APPENDIX C – COUNCILLOR SUBMISSION

**PLANNING REPORT TO
JOINT REGIONAL PLANNING PANEL
HUNTER AND CENTRAL COAST REGION
PROPOSED SUBDIVISION, WEST WALLSEND**

**APPLICANT
HAMMERSMITH MANAGEMENT PTY LTD**

Figure 2. Council's Landscape Officer Recommended Layout of Subdivision along the northern side of Withers Street.

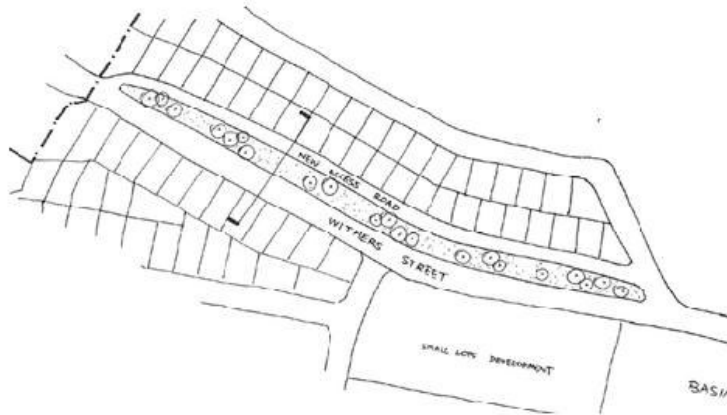
Some Council Officers have also raised a number of concerns relating to the Withers Street frontage. In relation to the northern side of Withers Street at the entrance to the proposed subdivision, Council's **Landscape Architect L Yang**

has proposed an amendment as indicated in Figure 2 below. I agree with this amendment.

I also consider that an amended design needs to address my concerns relating to the southern side of Withers Street which are outlined in this section of my report. Issues of excessive fill, loss of vegetation, rear fences along the Withers Road frontage and the proposed detention basin on the southern side are all concerns, which in my view, require resolution.

Figure 3. Council's Landscape Officer Recommended Layout of Subdivision near the Carrington Street entrance to the town.

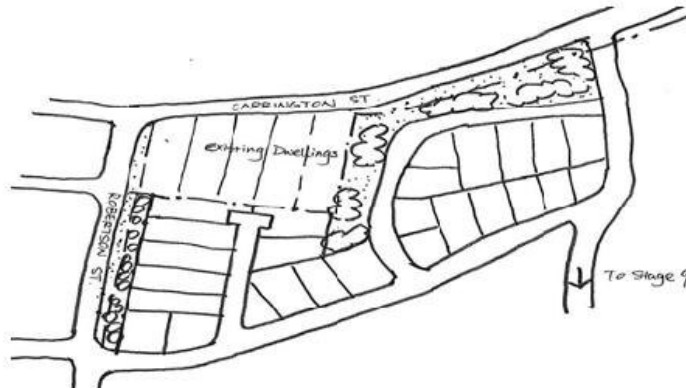
The Carrington Street entrance is described as a "second gateway" by the Applicant's Planning Consultant. The Applicant's Landscape Consultant also describes the entry as being "via open forest vegetation". The proposal includes several roads and lots to the south of Carrington Street. Council's Landscape Officer has raised a number of concerns about the proposed subdivision pattern in this location. The area is obviously an important gateway and as such, similar to the reasons listed above for the Withers Street entrance should retain a bushland character.

Council's Landscape Officer has proposed the following amendments (see Figure 3 below) which I support.
